COMPREHENSIVE PIPELINE INSPECTION REPORT

Project Name:	Mountain Valley Pipeline	Inspector:	Matt Grant
Inspection Date:	Tuesday, September 4, 2018		
Spread: Areas included: Appx St#14050+00-14057, St#13635+00-13638	Spread I	Weather (Wet/Dry/Rain):	Dry

PIPELINE INSPECTION REPORT

REQUEST FOR CORRECTIVE ACTION

Fig. 2

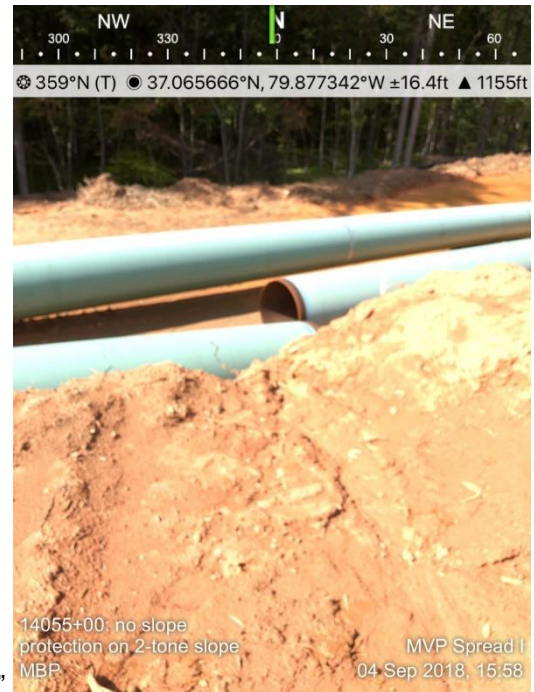
Description: Station 14055+00: Slope protection has not been constructed at waterbars in 2-tone areas

Fig. 4

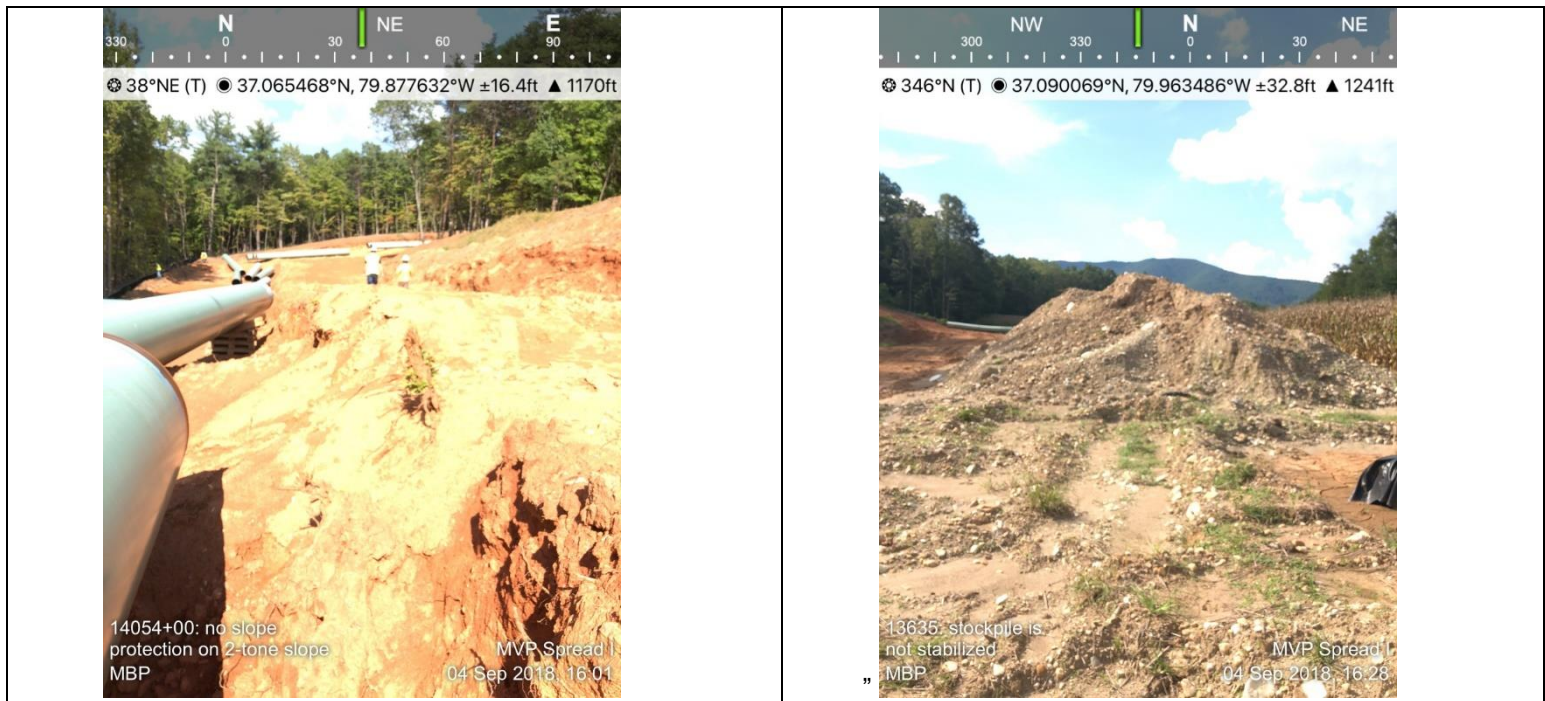
Description: Station 13635+00: Stabilization has not been completed on spoil stockpile

Location or Checklist #	Regulatory Citation/Legal requirement ¹	Observation/Recommended Corrective Action
8	Va. Code §62.1-44.15:31) (MVP Standards & Specifications for VA, pp. 3, 5	Observation: Corrective actions are not consistent with the requirements of the approved Annual Standards and Specifications. <u>Recommended Corrective Action:</u> Maintain all controls within the required time frame per the annual standard and spec.
11	Va. Code §62.1-44.15:31) (MVP Standards & Specifications for VA, p. 1) (9VAC25-870-54.B) (9VAC 25-840-40.1	Observation: 2 tone area near ST#14050+00 is not stabilized. <u>Recommended Corrective Action:</u> Stabilize areas per the MVP std & spec.
12	(Va. Code §62.1-44.15:31) (MVP Standards & Specifications for VA, p. 1) (9VAC 25-840-40.2).	Observation: St# 13635+00, stabilization has not been completed on spoil stockpile <u>Recommended Corrective Action:</u> Adequately stabilize stockpiles with seeding and/or protected with sediment trapping measures per the MVP std & specs.
